Re: **Application for a Zoning By-law Amendment**  
Innovative Planning Solutions on behalf of Found Group Development and 126 Ardagh Inc.  
**126 and 130 Ardagh Road, Barrie**  
**City File: D30-003-2026**

### Proposed Zoning By-law Amendment — File D30-003-2026

126 & 130 Ardagh Road, Barrie, Ontario (Ward 6)

**Image 1. Plan 126 & 130 Ardagh Road, Barrie (File D30-003-2026)**

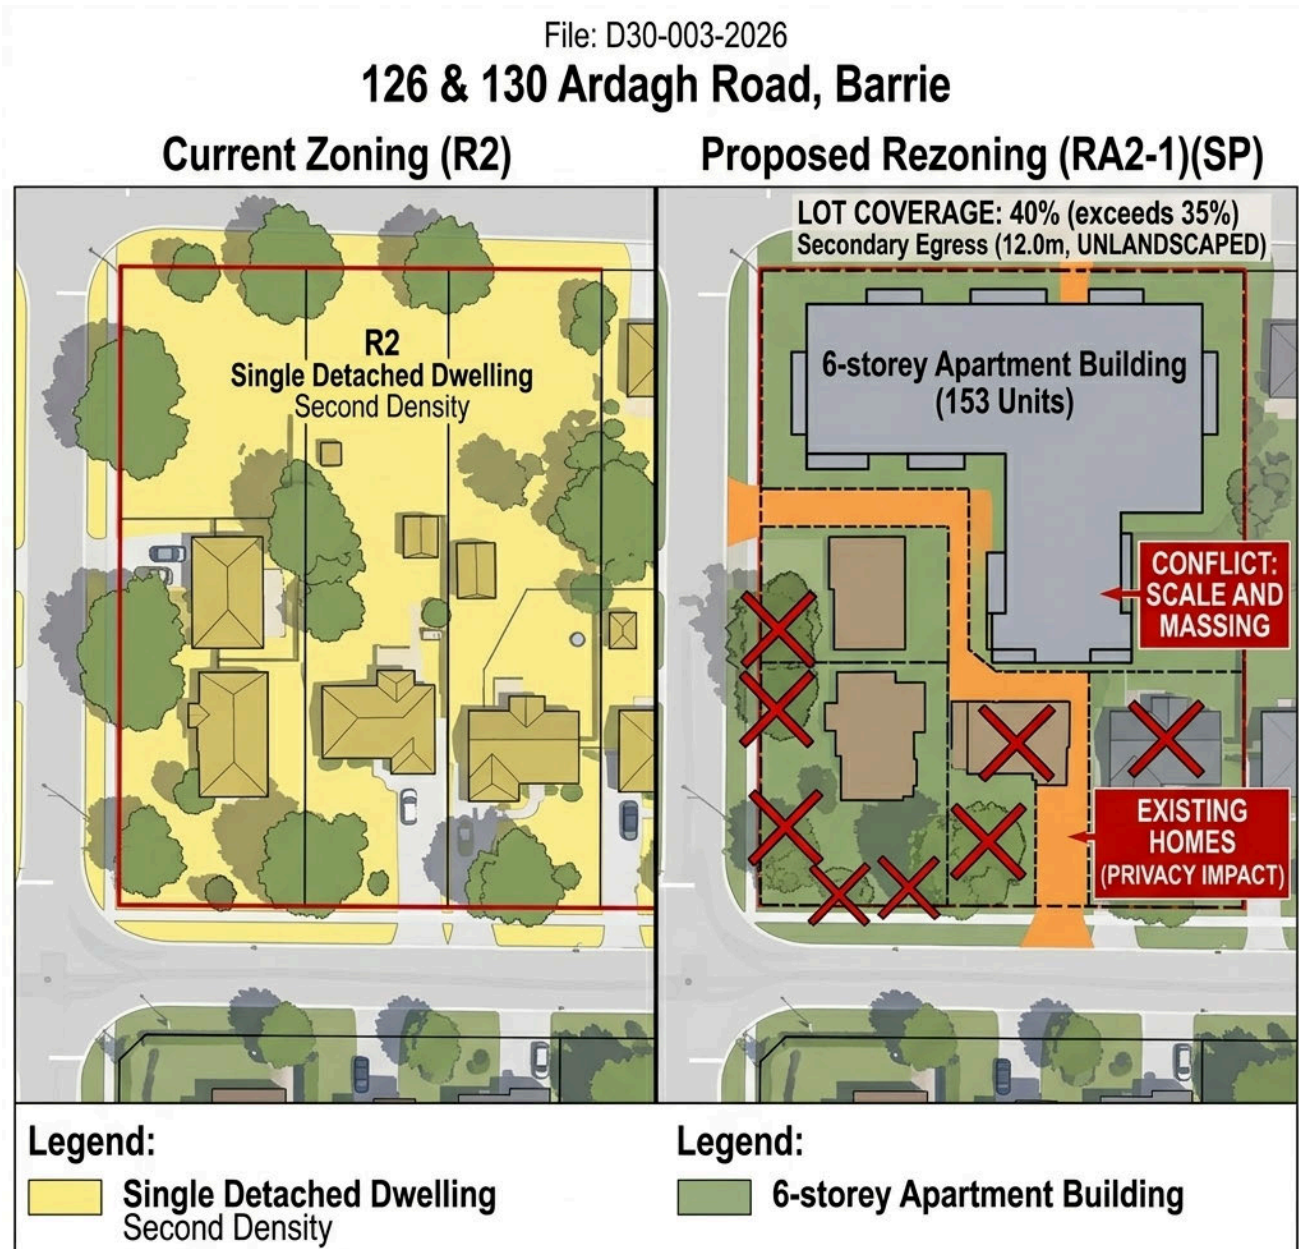
The developer is requesting a Special Provision to allow a 12.0-metre wide secondary egress that is NOT landscaped. This is a significant departure from the standard 7.0-metre landscaped buffer requirement under Zoning By-law 2009-141, Section 5.3.

The developer is requesting an increase in permitted lot coverage to 40%, compared to the standard maximum of 35% under Zoning By-law 2009-141 (see Exhibit A in Appendix B). This 5% increase in impervious surface may appear minor in isolation, but at this site scale it meaningfully increases stormwater runoff volumes entering the municipal storm sewer system.

Exhibit B: Streetscape Perspective — Scale Incompatibility and Failure of Step-Down Transition (File D30-003-2026)

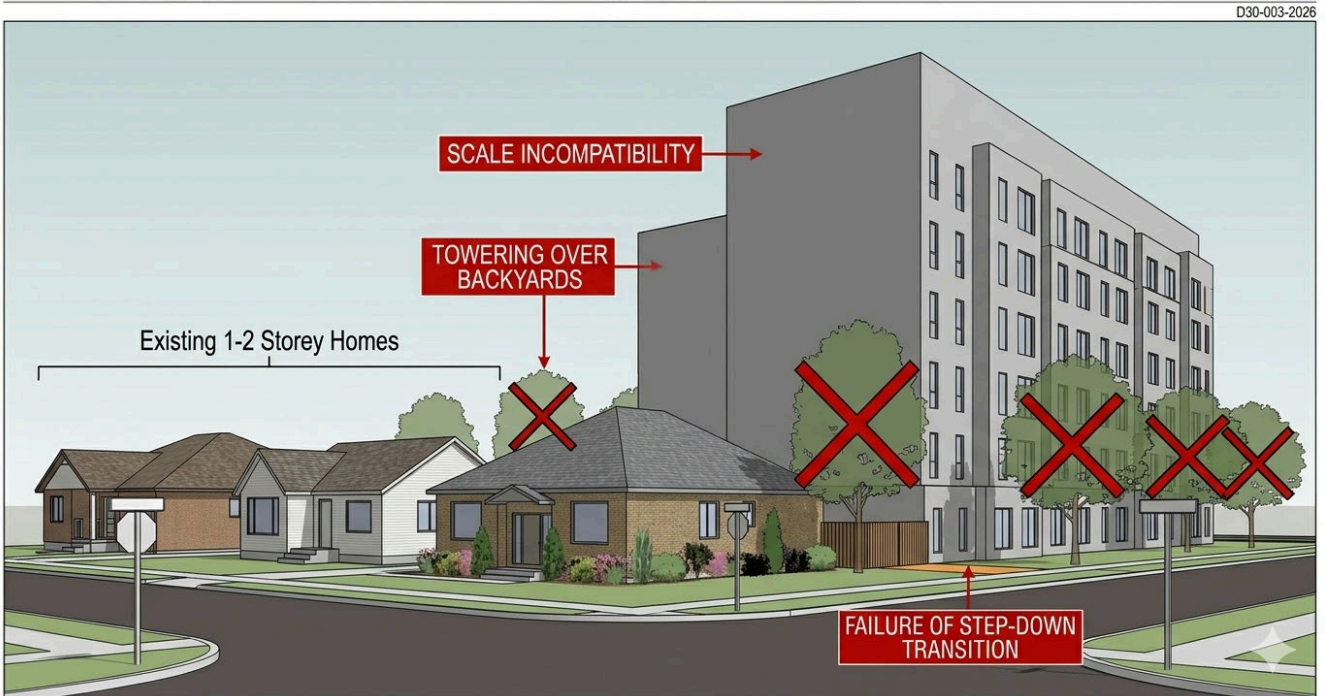
A 6-storey building placed directly adjacent to 1- and 2-storey bungalows is an abrupt massing change that is a violation of the City of Barrie Official Plan Section 3.1 regarding compatible transitions.

This streetscape perspective illustrates the massing incompatibility between the proposed 6-storey apartment building and the existing 1-2 storey homes along Ardagh Road. The absence of any step-down transition — from apartment directly to bungalow — constitutes a failure of compatible built form as required by the Official Plan.

Exhibit C: Subsurface Infrastructure Risk — Downstream Sanitary Sewer (Unverified Capacity) and Stormwater Overload Risk (File D30-003-2026)

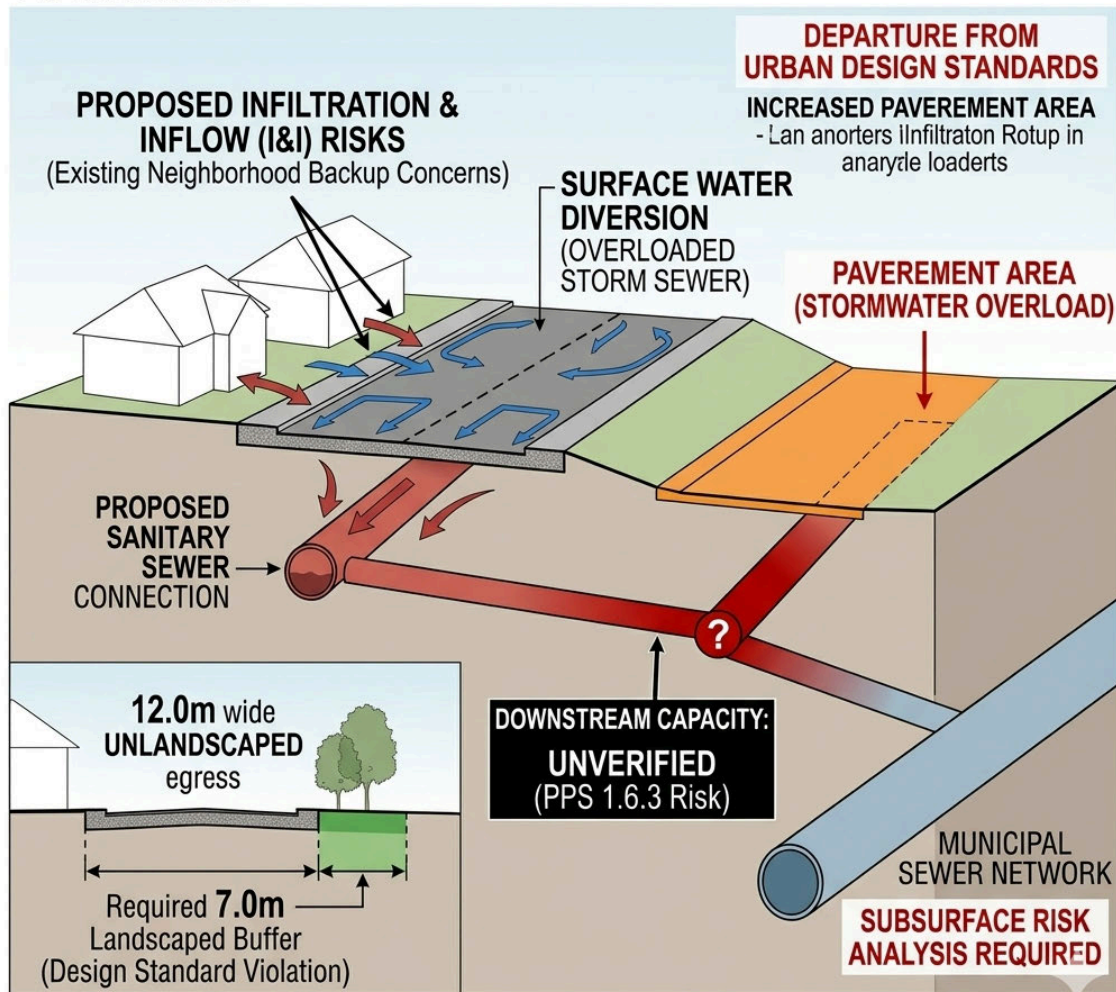
High-density infill in established low-density neighbourhoods routinely triggers Inflow and Infiltration (I&I) issues in aging municipal pipes. The sudden surge in daily sanitary flow from 153 units — effectively equivalent to adding a mid-sized apartment complex to a system designed for single-detached homes — creates a material risk of sewage backup into existing basements on Moon Drive and Patterson Road (see Exhibit C in Appendix B).

This schematic cross-section visualizes the downstream sanitary sewer risks and stormwater overload concerns arising from the proposed 40% lot coverage. It highlights the unverified downstream sewer capacity connection and illustrates the inflow and infiltration (I&I) risk pathway that could cause sewage backups in existing neighbourhood basements.
